RE: **Casitas de Colores – Grading & Drainage Plan for Building Permit**
215 Lead Ave. S.W. P.E. Stamp: 10/23/12 (**K14-D087A**)

**Re: Silver Town Homes, Silver & Second Street SE,
Request for Temporary Certificate of Occupancy - Not Approved
Engineer's Stamp dated 03/31/08 (K-14/D087)
Certification dated 02-09-10**

RE: Silver Townhomes, (K-14/D087)
Engineers Certification for Release of Financial Guaranty
Engineers Stamp dated 03/31/2008
Engineers Certification dated 2-25-10

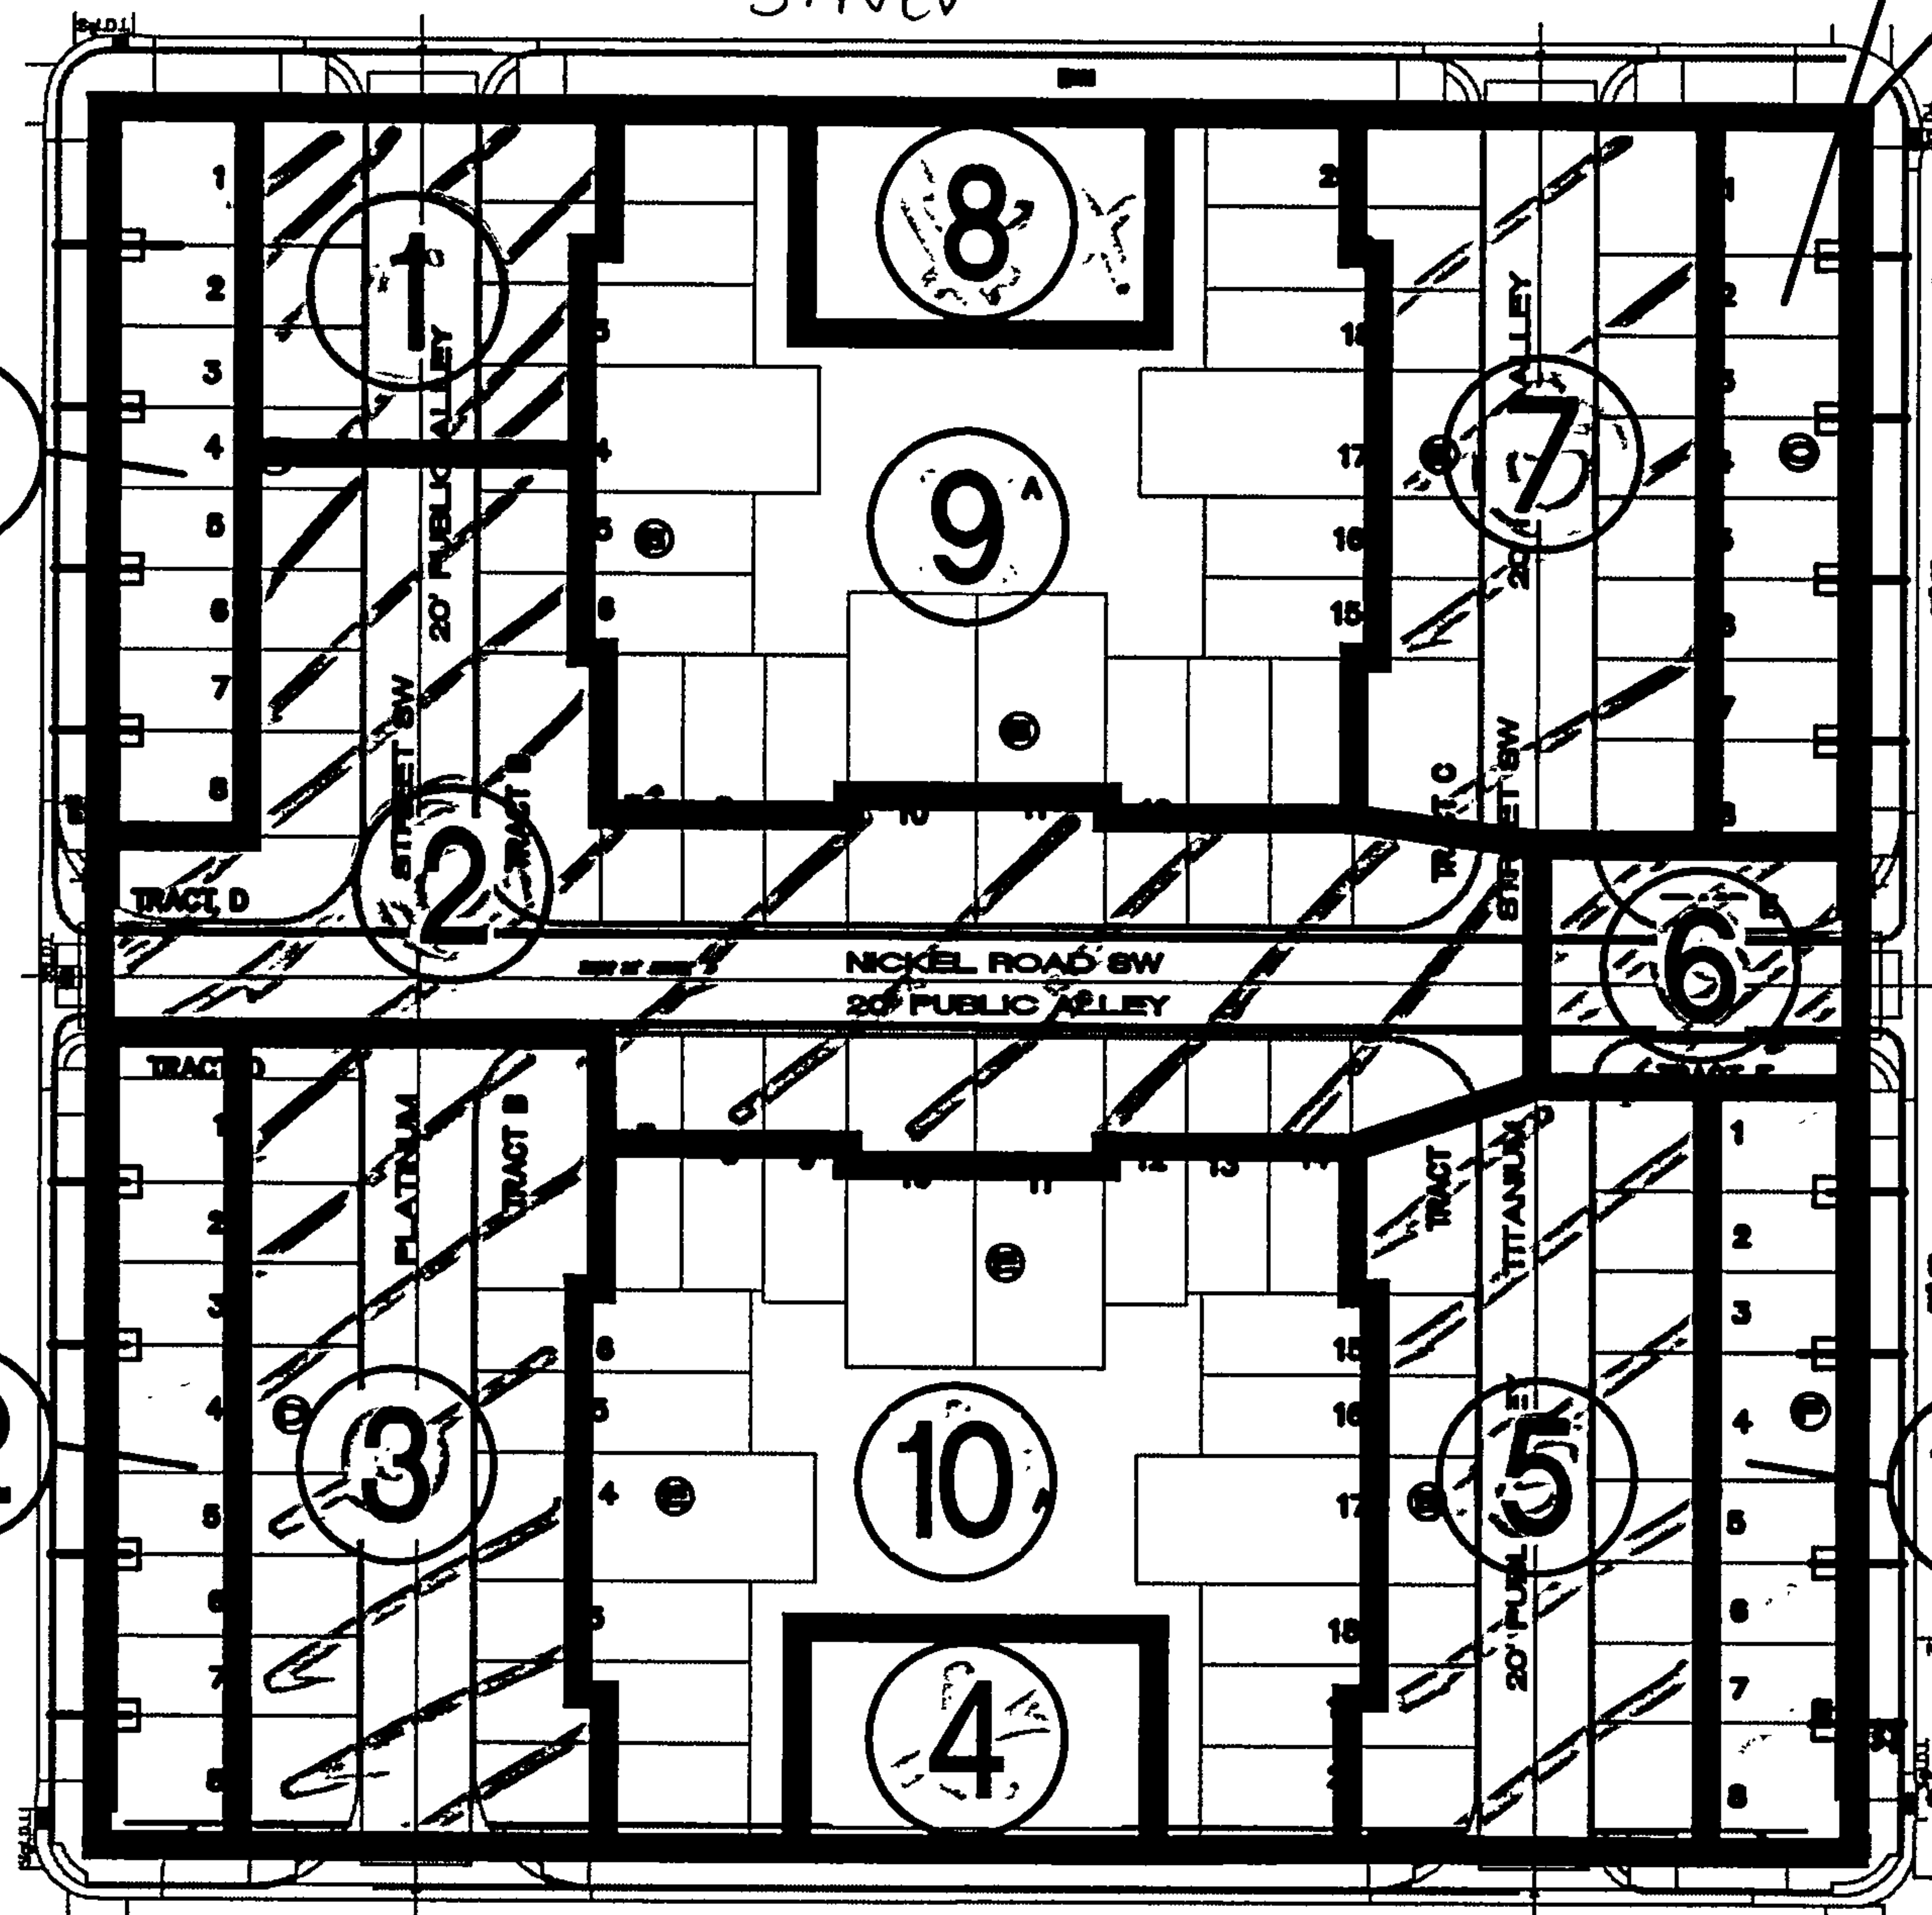
~~Roof discharge~~ from each townhome unit will be split with approximately 50% ~~draining~~ to the adjacent alley. ~~(Basins 1, 2, 3, 5, 6, & 7)~~ The other 50% drains to either 2nd Street or 3rd Street through PVC drains penetrating the curb (Basins 11, 12, 13, & 14), or to the internal private landscaping tracts (Basins 9 & 10). The two commercial tracts drain to either the landscaping tracts or Silver Ave or Lead Street through PVC drains penetrating the curb (Basins 4 & 8). (See Sub-Basin Map and associated calculations).

$$\frac{2.4}{9.0} \approx 9.1 \leq 9.4 \text{ cfs}$$

[Handwritten notes and calculations at the bottom of the page, including "A_c = C_{200}" and "Q_p = ..."]
